COMMENTS RELATING TO PLANS FOR ENLARGEMENT GROUND-FLOOR EXTENSION - 10 EVANGELIST ROAD

PHOTO 1 - INTENDED LOCATION ENLARGED EXTENSION NO 10.

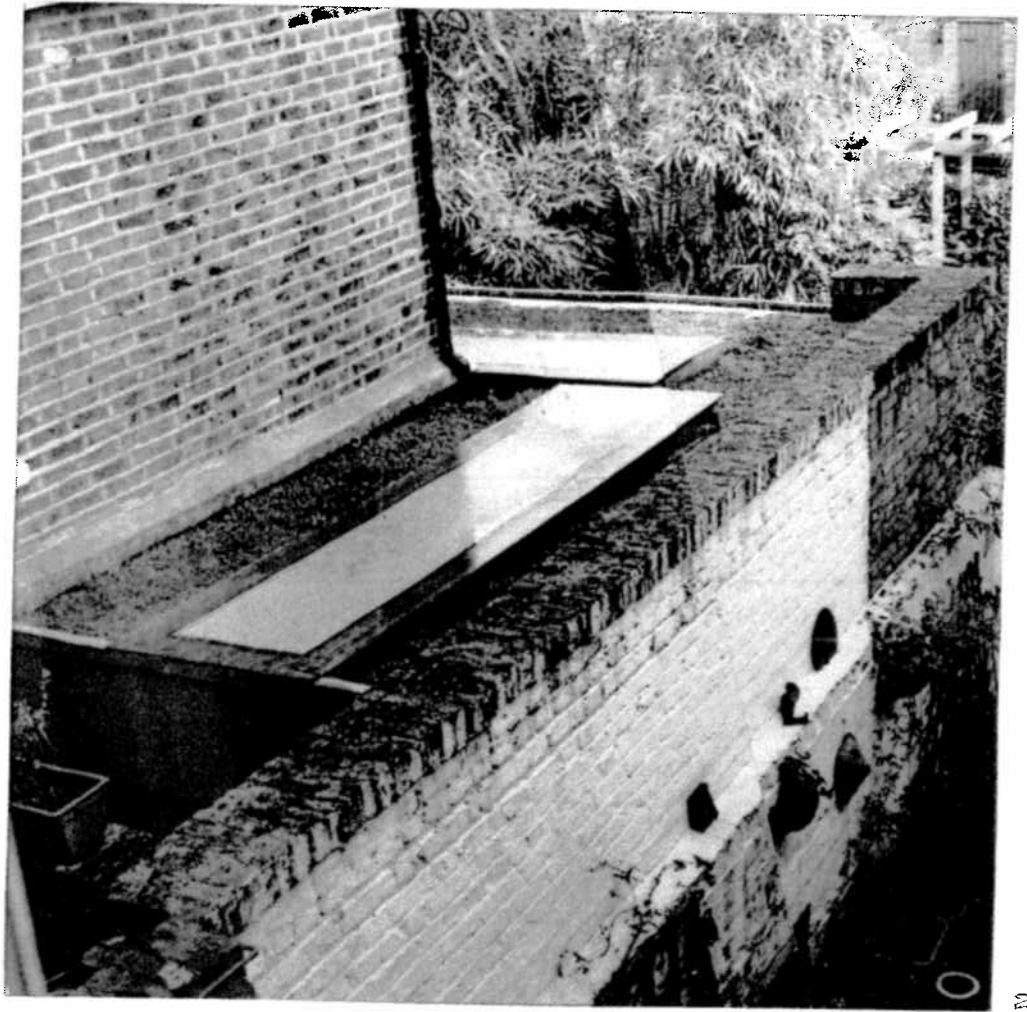
I have already commented on the impact to the first-floor flat that any building-out of the ground floor rear extension is likely to have. The plans confirm that as a result of such an enlargement, it would be surrounded on all sides by built-up space, and that consequently the sense of enclosure, loss of privacy, compromised outlook - and security - already initiated by the development at no 12, would be intensified; whilst the direct and open views onto the gardens would be lost.

PHOTO 3 shows part of the existing conservatory roof in the space where the patio would be sited

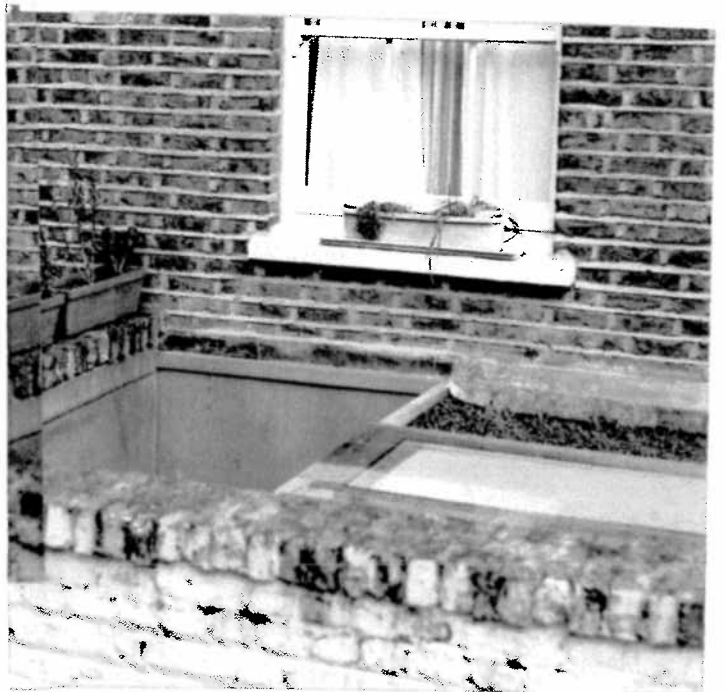
- In its proportions and location the 'patio' space very much resembles the 'lightwell' of the enlarged extension at no. 12, which has not, in my view, been a design success, and is proving to be a source of noise nuisance. Viewed from above, the two spaces would be almost - but not quite, adjacent, and not especially attractive.

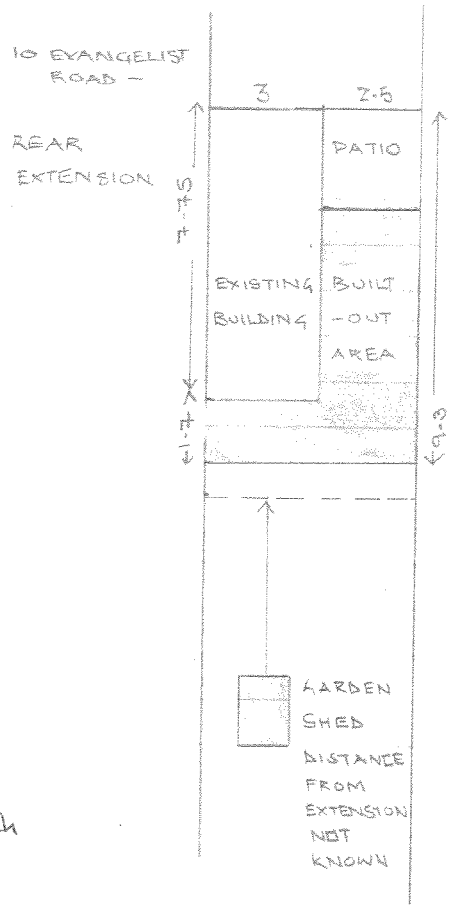
1. The built-out area should measure about 2 1/2 m across, which is the width of the existing garden passage. On the drawings, the space is shown as extending by the same amount all around the building - but only measures 1 1/2 m, which is much narrower than the garden passage. It is therefore unclear whether the end wall at the rear should be built out by 1 1/2 m, or adjusted to 2 1/2 m. In the rough drawing to the right, I have given this measurement as 1.7 m, which is what appears on the proposed side-elevation and long-section drawings.

2. According to my calculation, the length of the existing extension is around 7.75m. This is shown correctly in the plans, which give the overall built-out extent of the enlarged structure as 9.3 m.

3. The height of the glass roof is shown as 2.7 m on the elevation drawings.

According to my calculation, these dimensions should give an overall volume of 76.54 cubic metres.
